RE: Permit No. C1006MN – Revised Permit Modification Application for Ray Claims No. 4 and No. 6 Mine, Cibola County, New Mexico

Permit No. CI006NM - Permit Modification Application for Ray Claims No. 4 and No. 6 Mine, Cibola County, New Mexico

Figure 1. Approximate Location of Proposed Access Road Water Bars

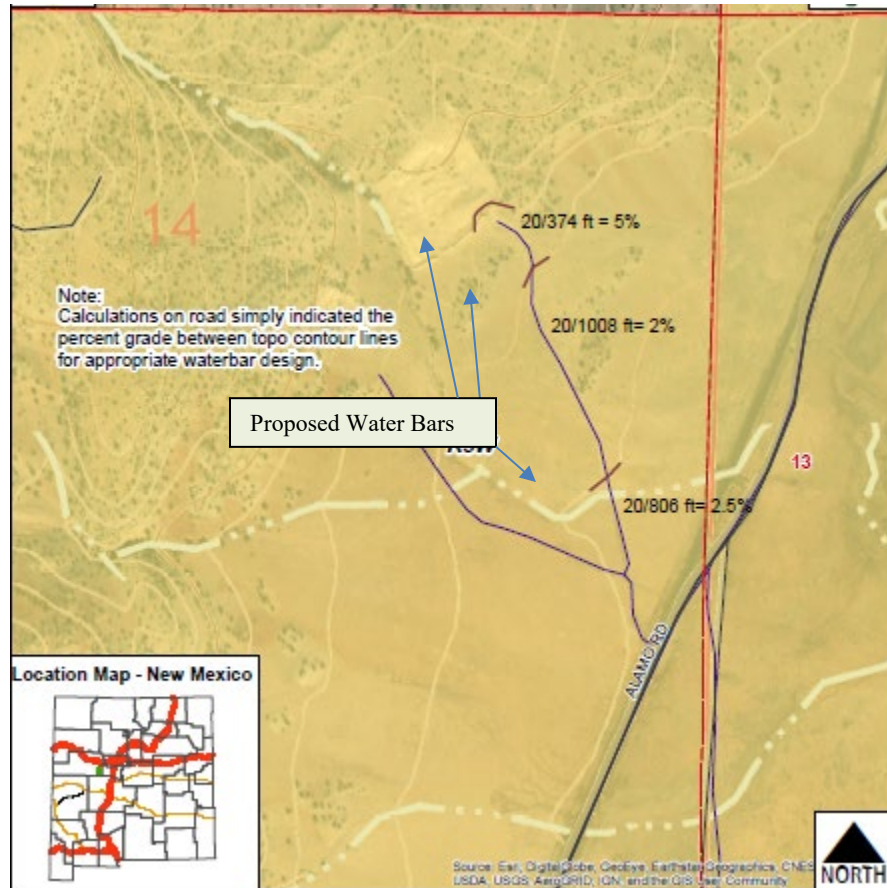
7. A fence and/or barrier and signage will be installed on top of the highwall to prevent vehicles and foot traffic from approaching the highwall unknowingly from behind.
8. Access Road – Water bars will be placed at strategic locations along the road, as shown in Figure 1 below, to channel water off the road toward the down-sloped side, to avoid erosion. The road will remain open to allow multiple use access to the area.
